ADDENDUM NO. 4

RE: North Texarkana Wastewater Treatment Plant Improvements

ADDENDUM DATE: September 8, 2026

AERATION BASIN DETAILS

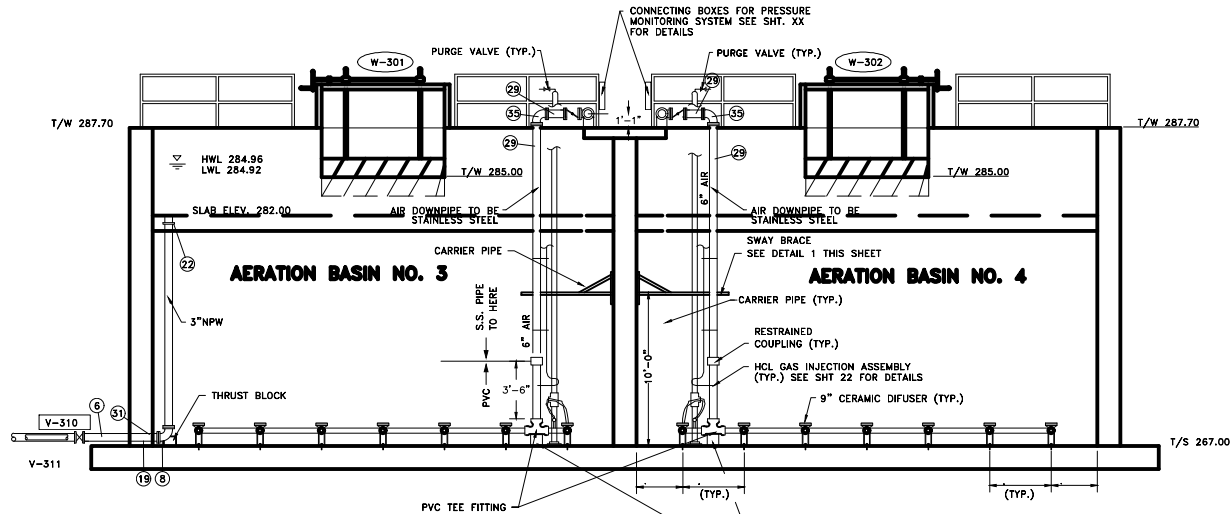
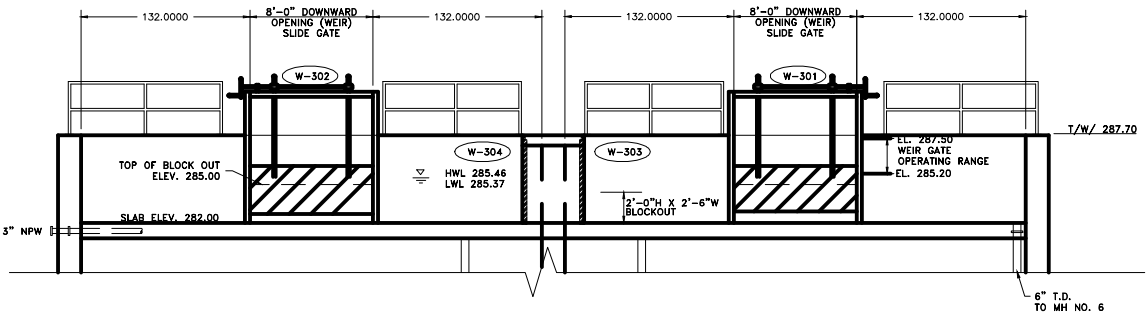
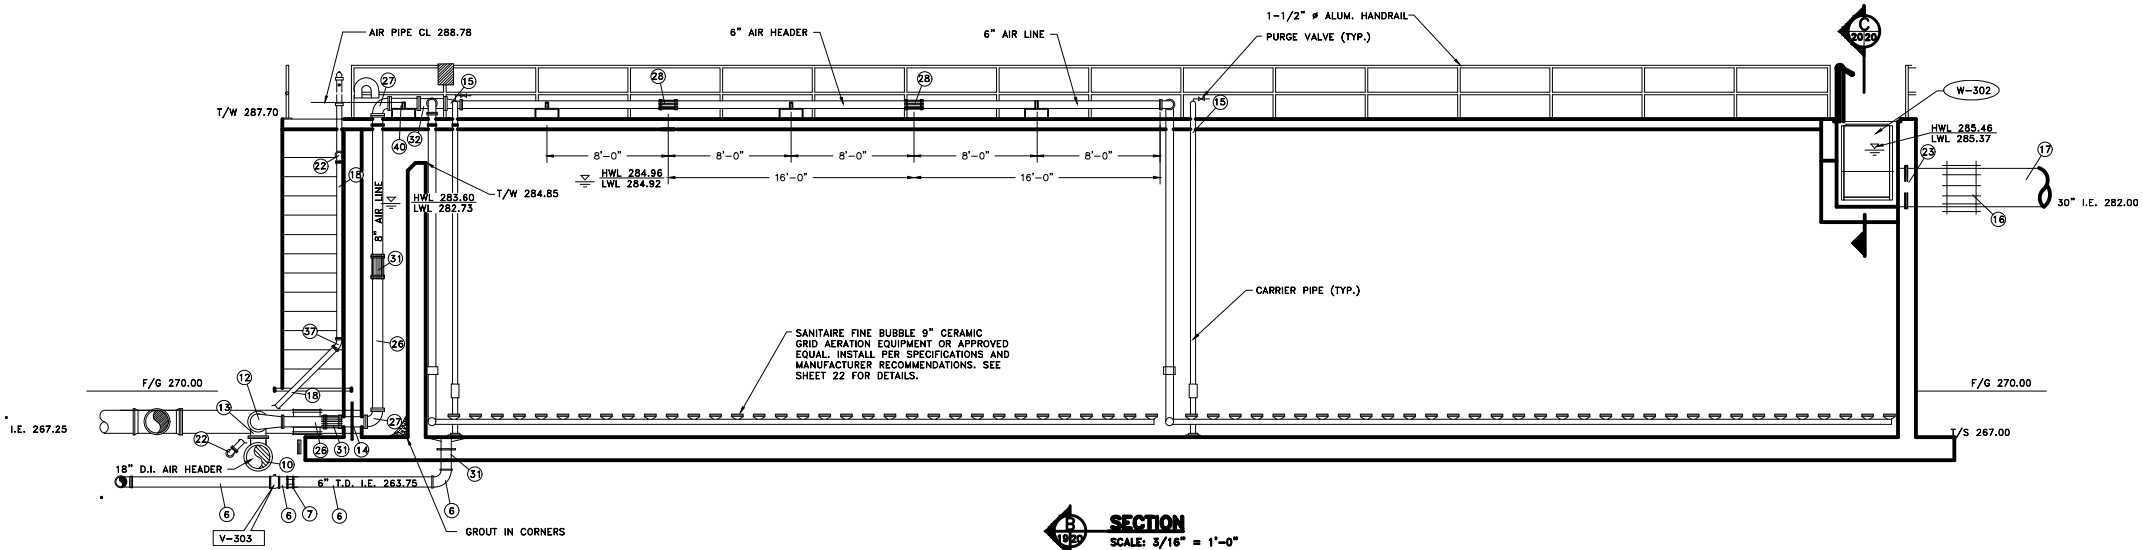
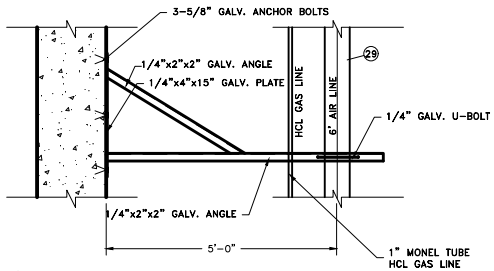
3. No new bollard are needed for screening dumpster.
4. Aeration basin down pipes shall be stainless steel. Sheet 17.
5. No local permits are expected, Engineer is currently processing ADEQ construction permit for the WWTP expansion. Engineer will develop a small construction site permit for ADEQ SWPPP plan. Contractor will be responsible for posting site notices, inspections of sediment controls and upkeep of the stormwater permit through construction to ADEQ requirements.

9-6-26	3-AIR DOWNPIPE UPDATED TO S.S.	CJM
Date	Revision	By
